Access Compliance Report

Public Rights-of-Way

Intersection ID: 24744	Main Street: CHOATE_CR	Cross Street: FRESHWELL_RD	Location: NW
ADA ID: 1F55D4B8FEDA	Ramp Type: PerpDiag	Initial Pass/Fail: Fail	Overall Compliance: No
		Severity Score: 37.5

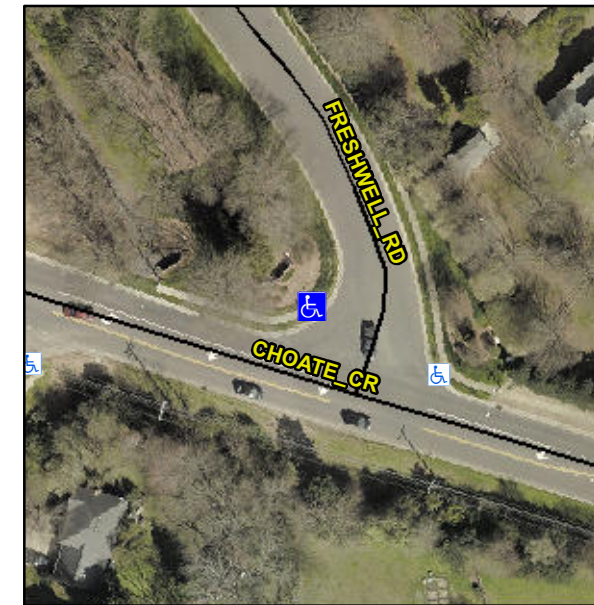
R304.2.2, R304.5.3

Compliance	Description	Data	Compliance	Description	Data
N/A	Ramp Length (in)	51.0	No	Ramp Slope (%)	12.0
Yes	Ramp Width (in)	48.0	No	Ramp XSlope (%)	6.1
N/A	Flare Type LT	N/A	N/A	Flare Type RT	N/A
N/A	Flare Slope LT (%)	N/A	N/A	Flare Slope RT (%)	N/A
N/A	Flare Traversable LT?	N/A	N/A	Flare Traversable RT?	N/A
N/A	Landing Length (in)	N/A	N/A	DWS Provided?	N/A
N/A	Landing Width (in)	N/A	N/A	DWS Contrast?	N/A
N/A	Landing Slope (%)	N/A	N/A	DWS Length (in)	N/A
N/A	Landing X Slope (%)	N/A	N/A	DWS Full Width?	N/A
N/A	Landing Curb? (Y/N)	N/A	N/A	DWS Offset (in)	N/A
N/A	Shared Landing?	N/A			
N/A	Gutter Ponding?	N/A	N/A	Gutter Slope (%)	N/A
N/A	Gutter Lip Ht (in)	N/A	N/A	Gutter X Slope (%)	N/A
N/A	Painted X Walk1?	No	N/A	Painted X Walk2?	No
	X Walk 1 Direction	To SW		X Walk 2 Direction	To SE
N/A	X Walk 1 Width (in)	N/A	N/A	X Walk 2 Width (in)	N/A
	X Walk 1 Slope (%)	0.0		X Walk 2 Slope (%)	3.6
	X Walk 1 X Slope (%)	2.0		X Walk 2 X Slope (%)	0.3

Remove & Replace Curb Ramp With Two New Directional Ramps or Equivalent.
